Final Drainage Report  
for  
**Meridian Service Metropolitan District**  
**Recreation Center East Fieldhouse**

PCD Project No. PPR246

**Meridian Service Metropolitan District  
Recreation Center East Fieldhouse  
Final Drainage Report**

# MSMD FIELDHOUSE - FDR DEVELOPED CONDITIONS

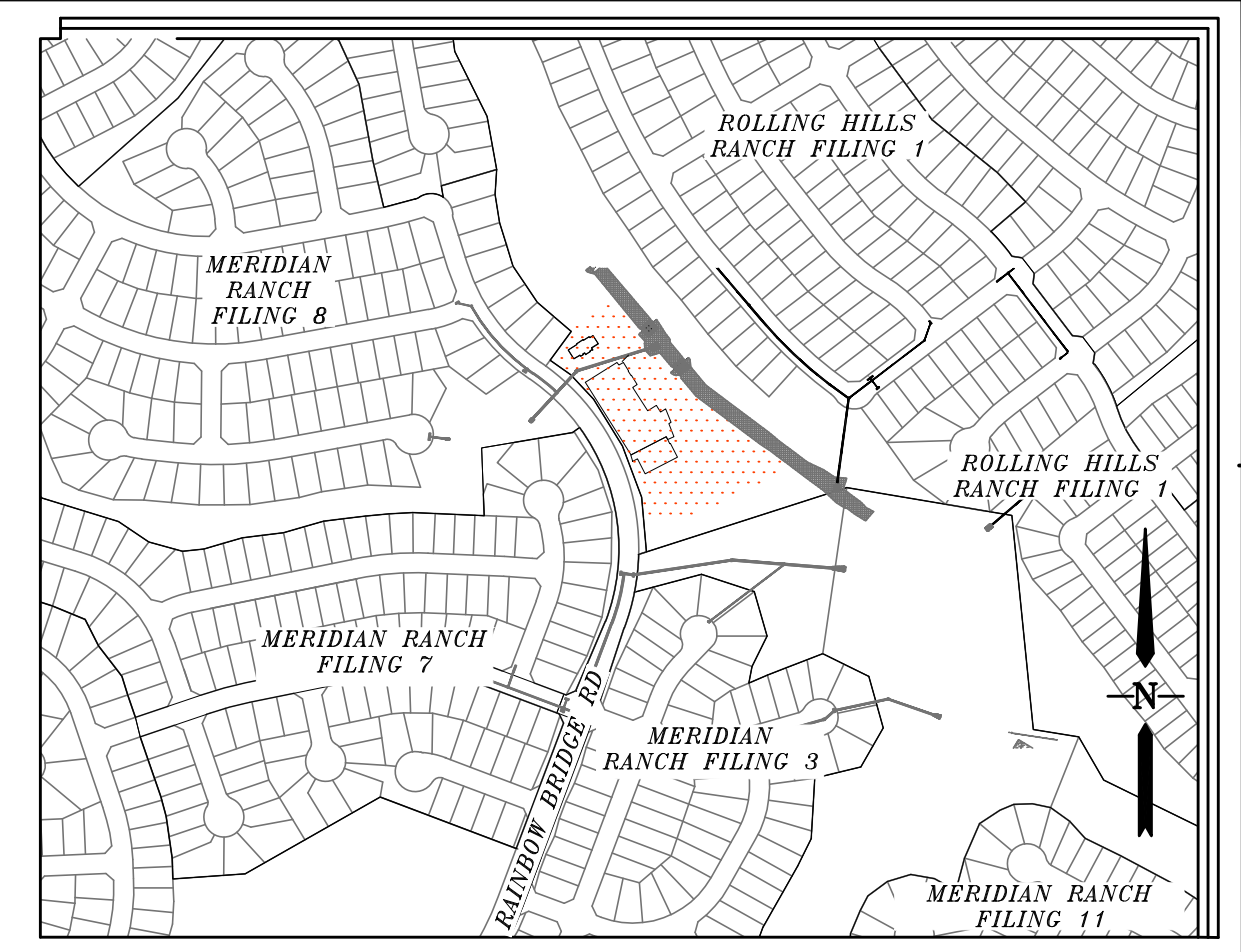
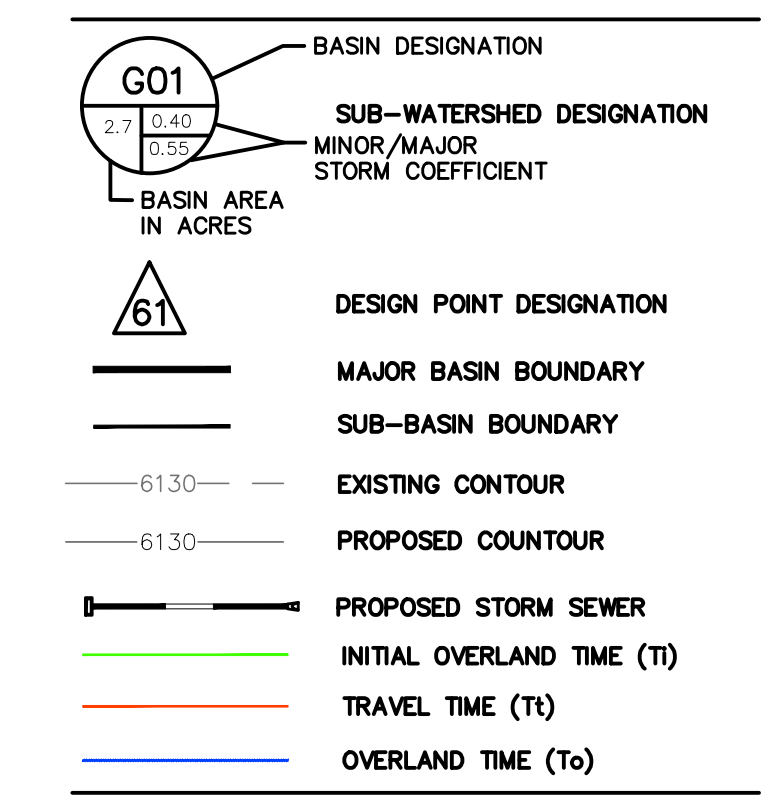
Erosion may occur where the concentrated flows meet the existing grade. Please provide calculations showing the velocities this swale will experience.

Unresolved: Analyze and identify if any protection is needed at rundown to the channel.

Unresolved: Show grass swale to channel.

Unresolved: provide analysis of the required outfall protection in the drainage report

Unresolved: Proposed and existing contours are not well defined. Modify weighting or change color. Label contour lines.
